Re: Ballaghveny Landfill Waste Licence Review Application - Waste Licence 78-2

ARTICLE 12 COMPLIANCE REQUIREMENTS

WASTE LICENCE REVIEW APPLICATION

ARTICLE 12 COMPLIANCE REQUIREMENTS

Drawn by:	C.N.	Job No:	060504001
Checked by:	S.A.	File No:	060504001DG0150
Approved by:	W.M.	Drg. No:	
Scale:	1:1250		
Date:	Jul '04	DG0150-01	F01

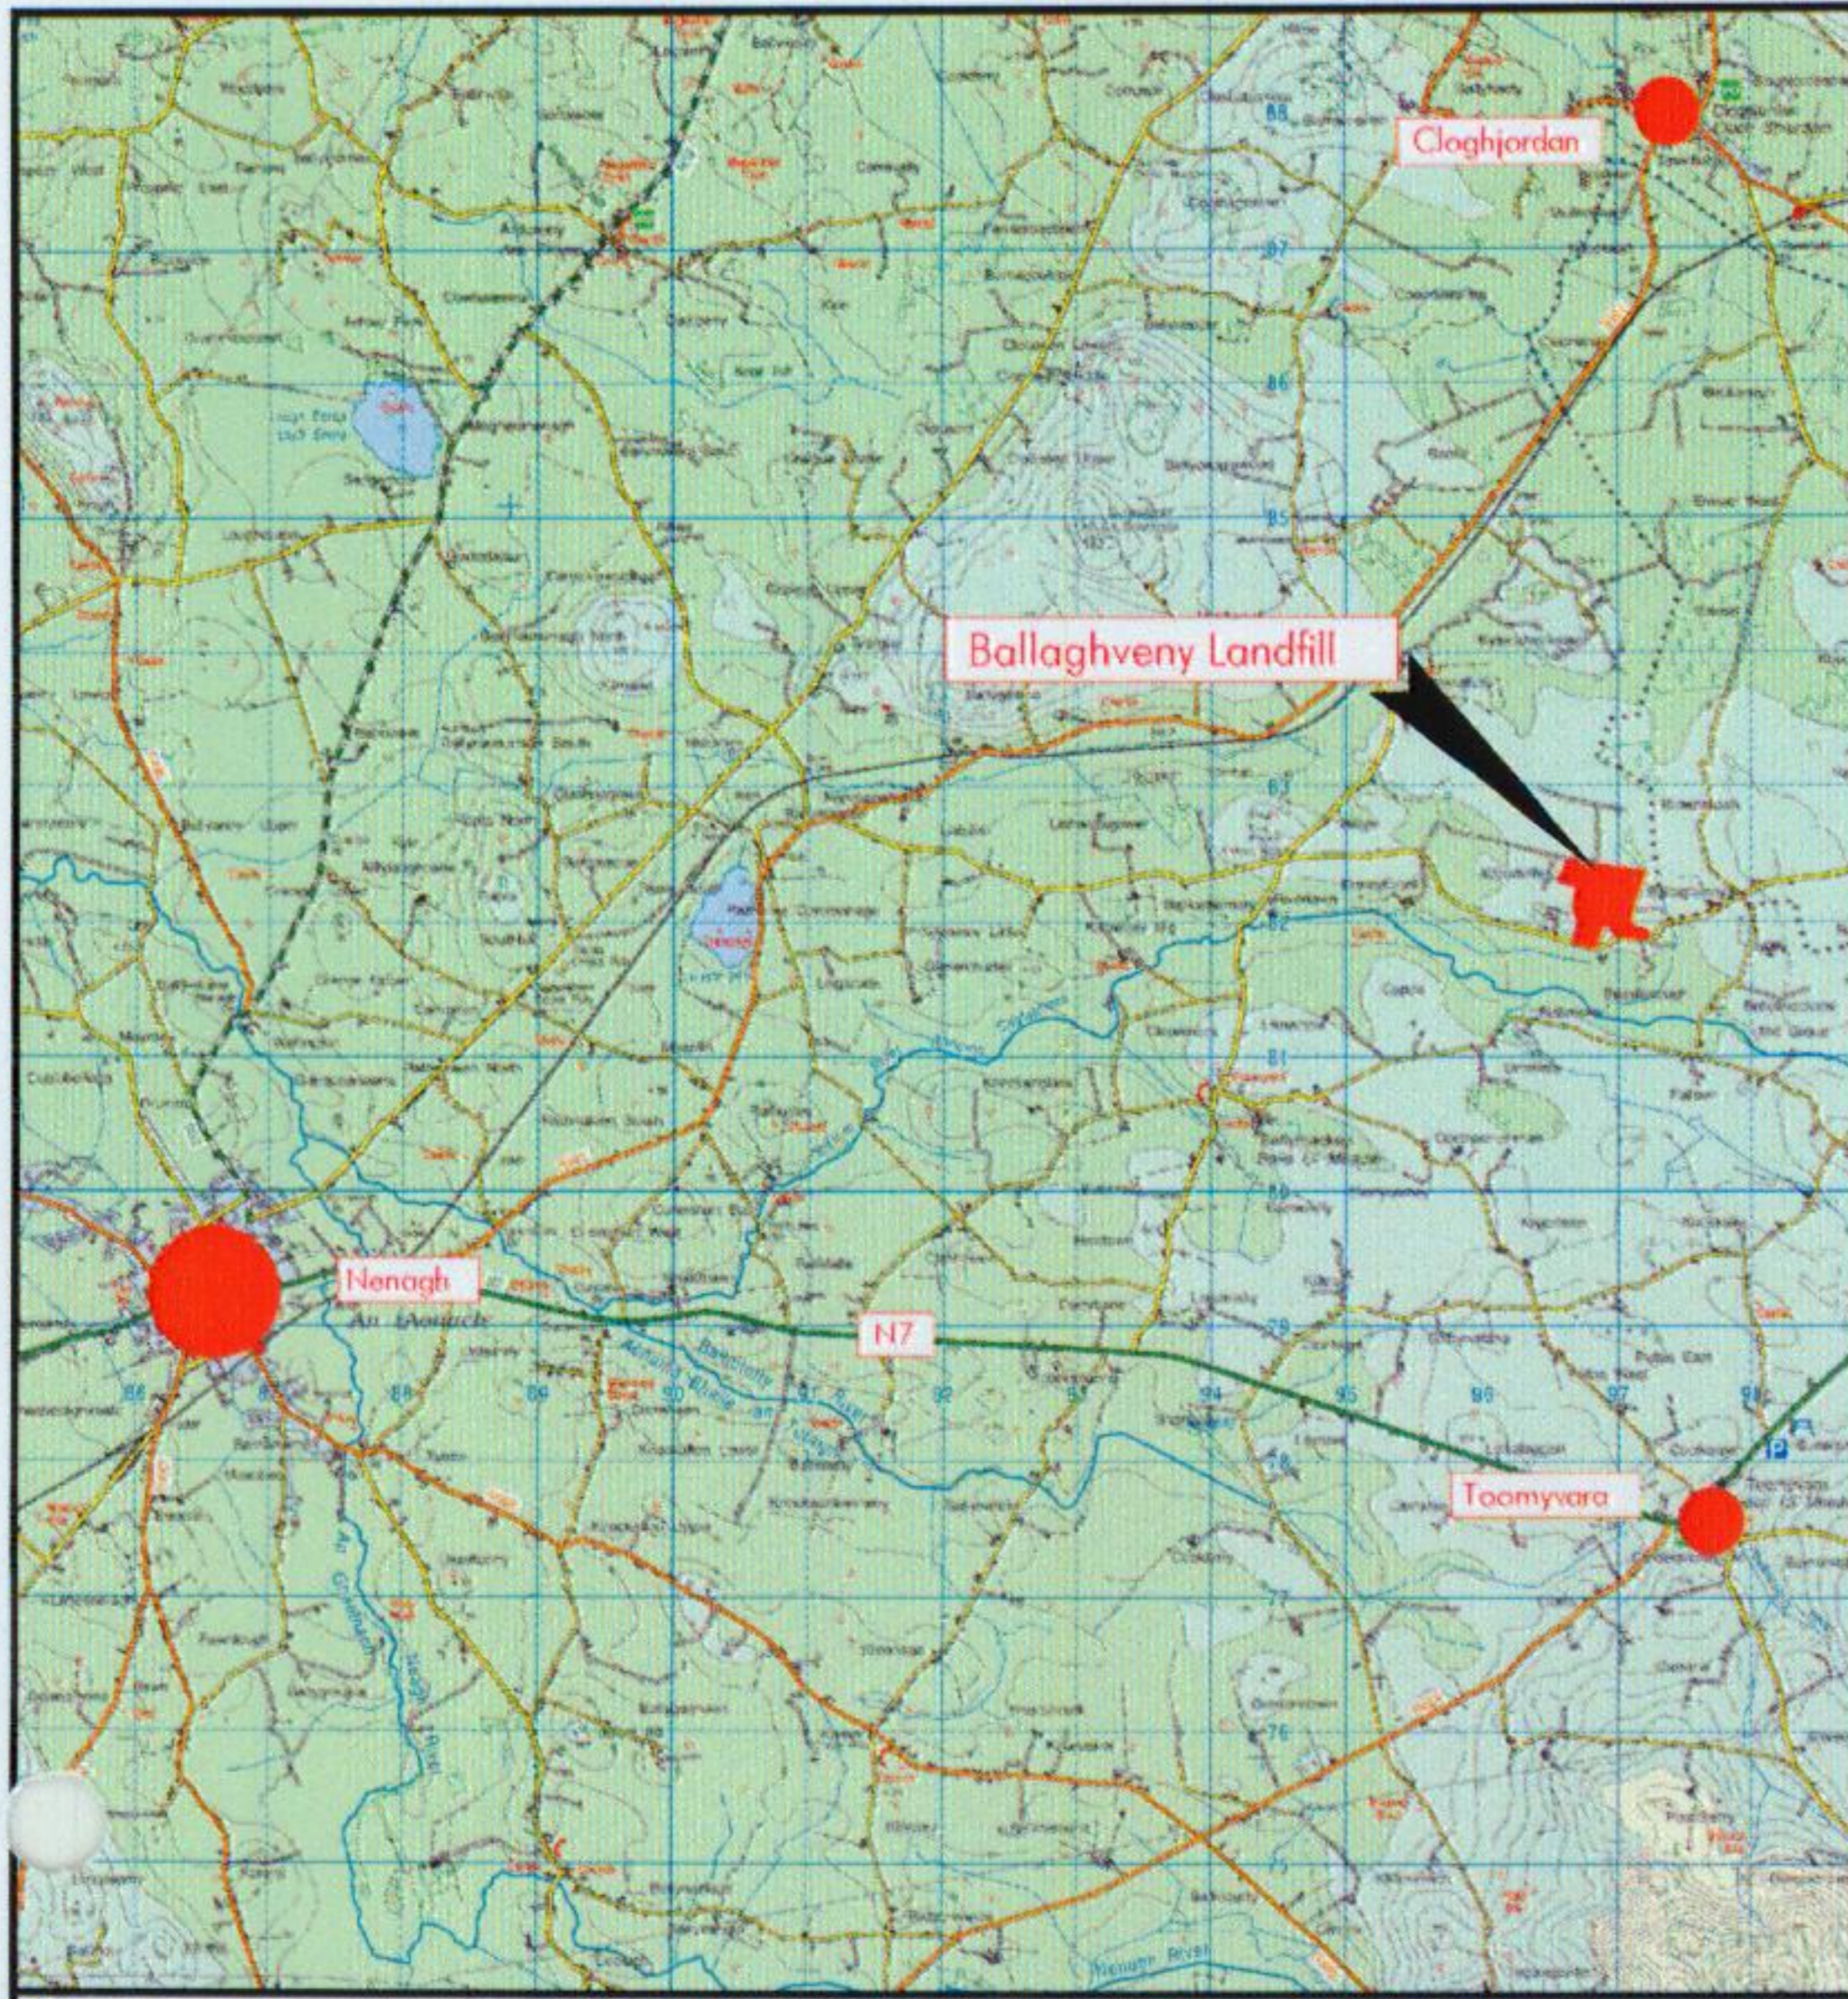
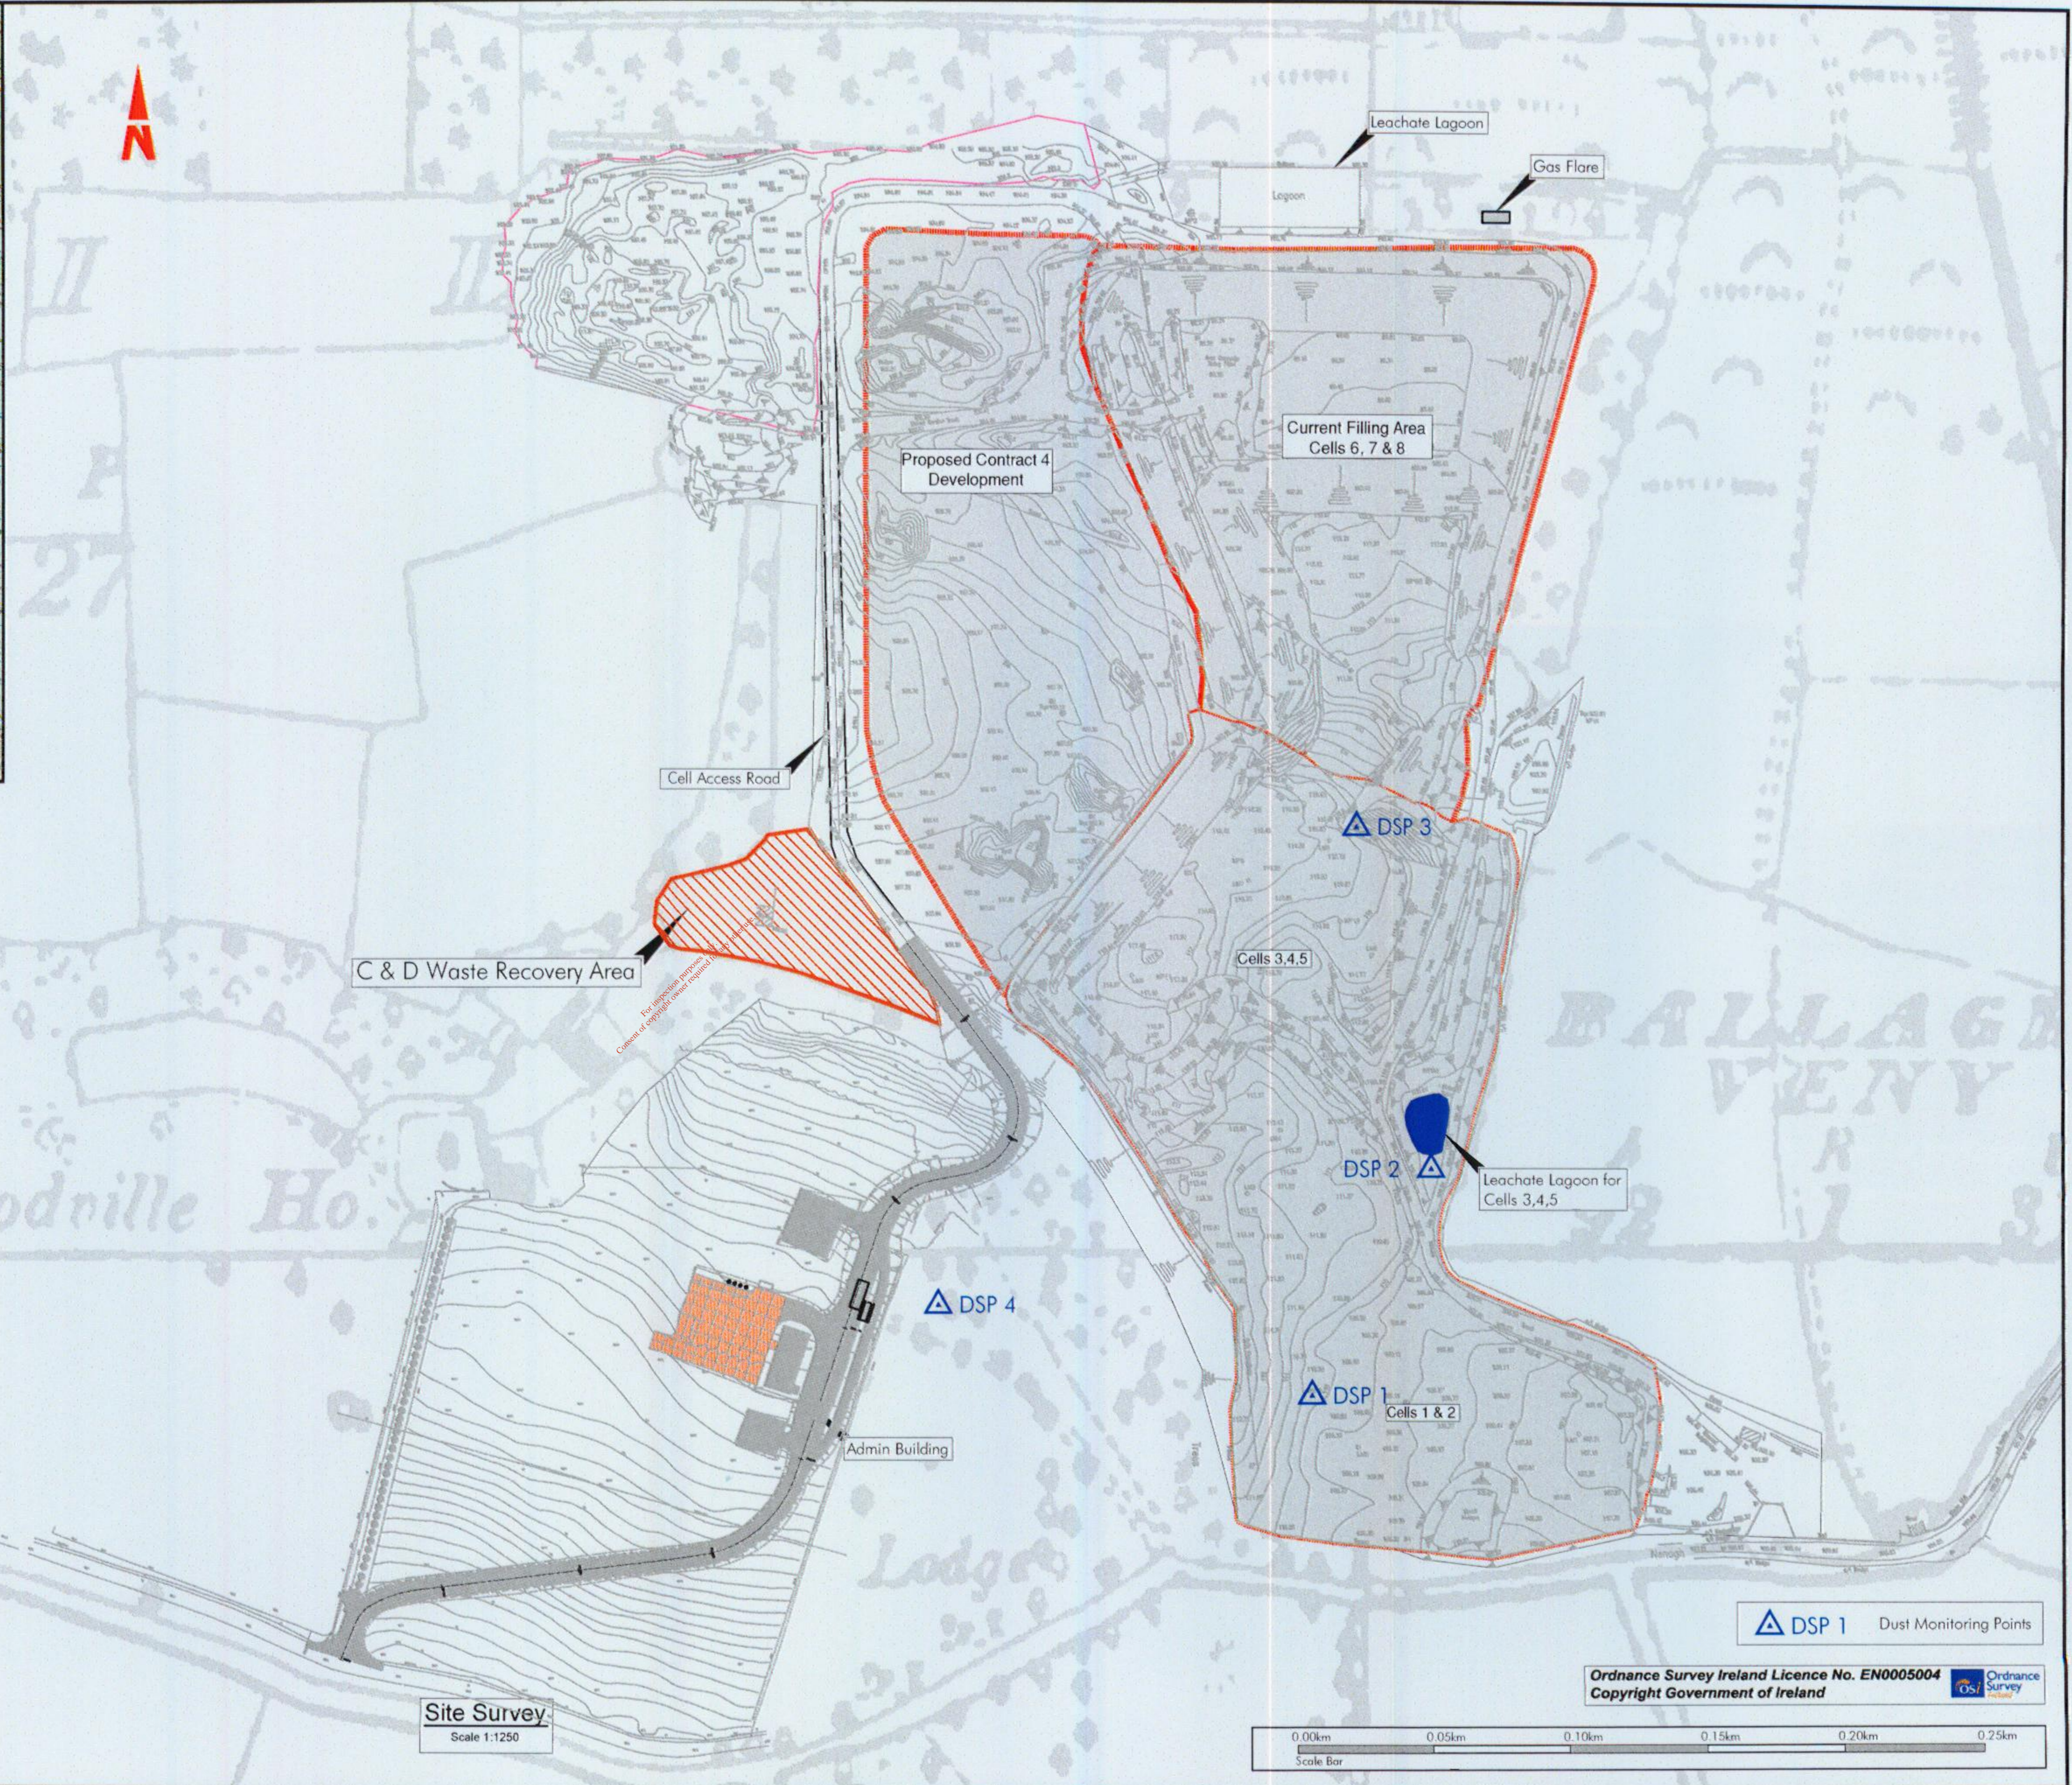
1. Provide details on emissions (dust, noise, surface water run-off etc.) in relation to the proposed processing of construction and demolition waste to be carried out at the facility. Include an assessment of the environmental impact of the emissions from the recovery of construction and demolition waste as well as any proposed mitigation measures.

Table 1 below presents some typical dust monitoring results for Ballaghveny Landfill. DSP4 is the nearest monitoring location to the proposed C&D waste recovery area (Drawing No. DG0150-01). The standard emission limit of 350 mg/m²/day is not exceeded at any of the four locations. Therefore the existing landfill is not having a negative impact on the surrounding air quality. The dust monitoring programme at the facility will be extended to include this proposed area for recovery of C&D waste.
